### **ADDENDUM # 6 Bid 20C6, Waverley Elementary School - New Construction**

## **ADDENDUM NO. 6**

RE: **WAVERLEY ELEMENTARY SCHOOL REPLACEMENT**

8 SECTION  
S4.7 1" = 1'-0"

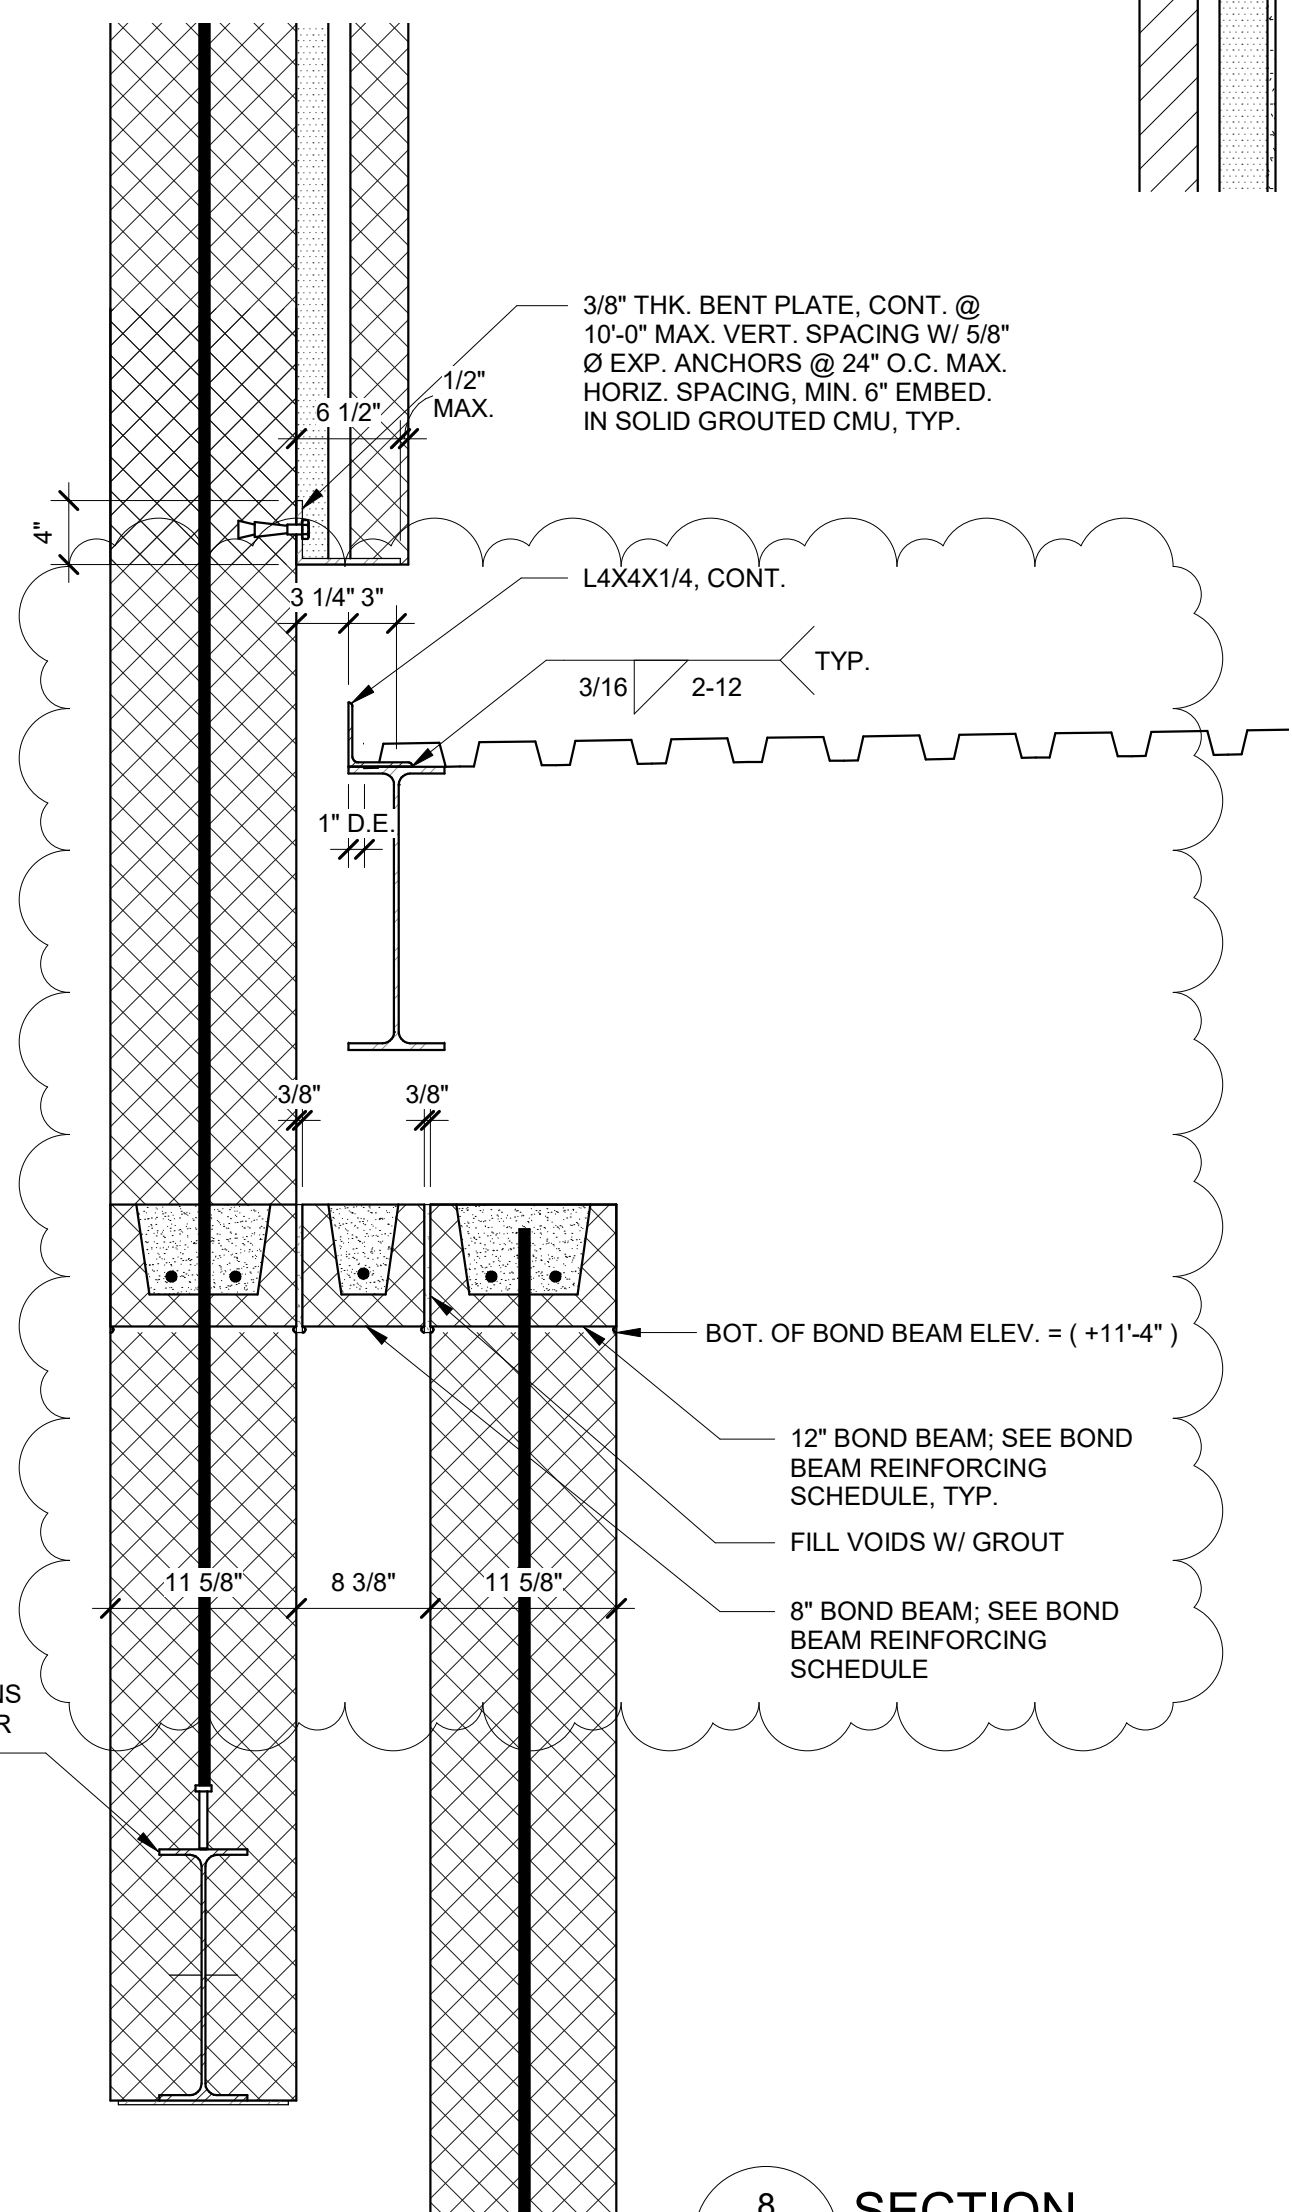
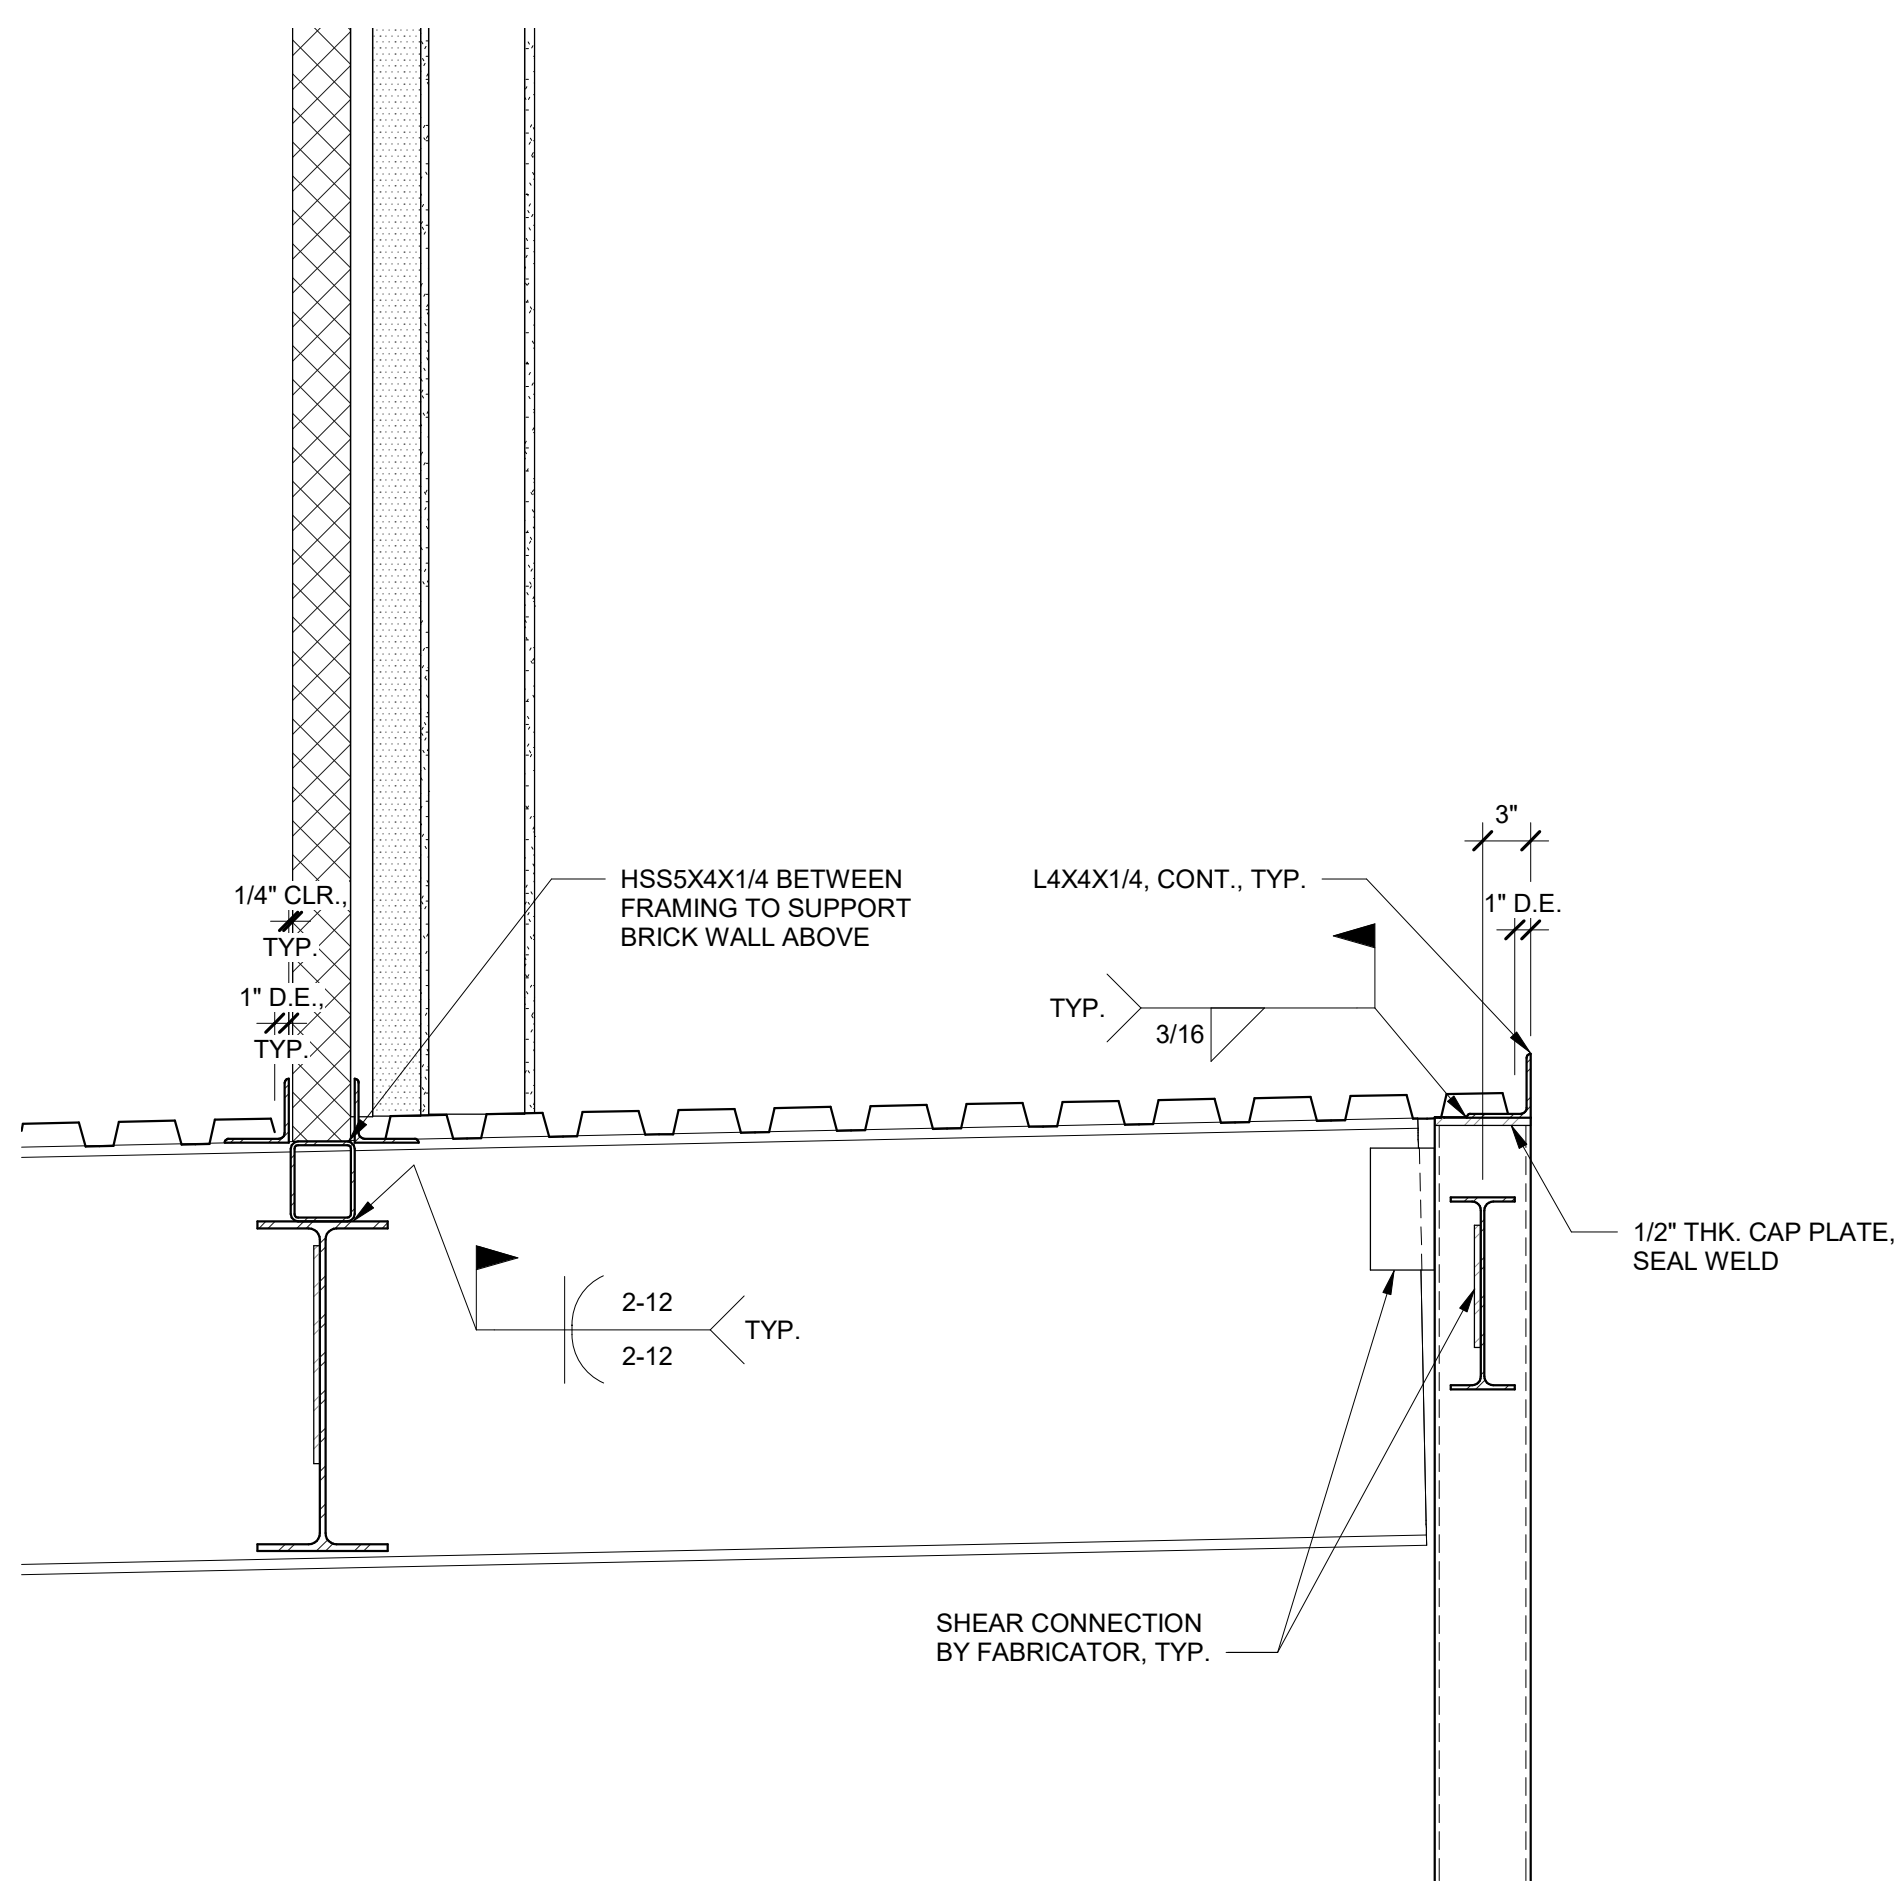
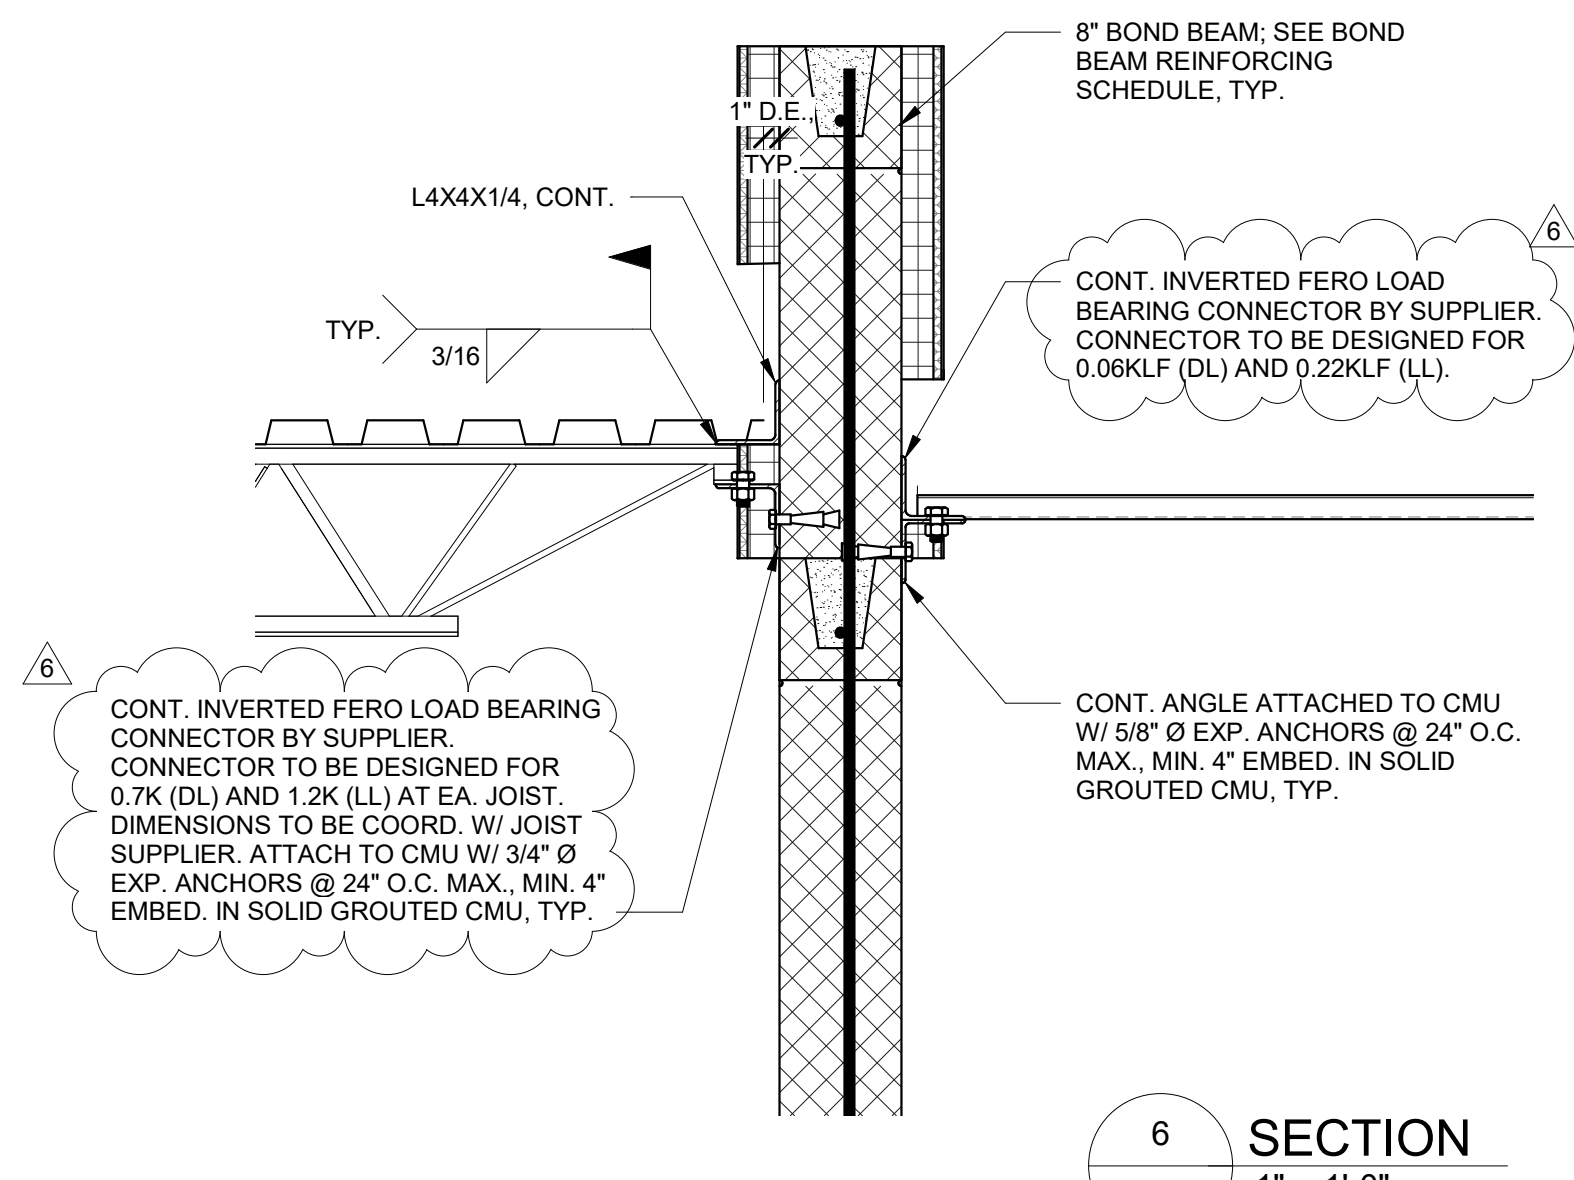
- **REVISE** WT size to “WT12.5X27.5” in detail 2/S4.6.
13. **DELETE** Drawing Sheet S4.7 – ROOF FRAMING SECTIONS; Issued for Bid, dated 03/06/2020; **ADD** Drawing Sheet S4.7 – ROOF FRAMING SECTIONS; ADDENDUM #6, (Revision dated 04/22/2020).

- **REVISED** details as indicated.
14. **DELETE** Drawing Sheet S5.1 – JOIST LOAD DIAGRAMS; Issued for Bid, dated 03/06/2020; **ADD** Drawing Sheet S5.1 – JOIST LOAD DIAGRAMS; ADDENDUM #6, (Revision dated 04/22/2020).
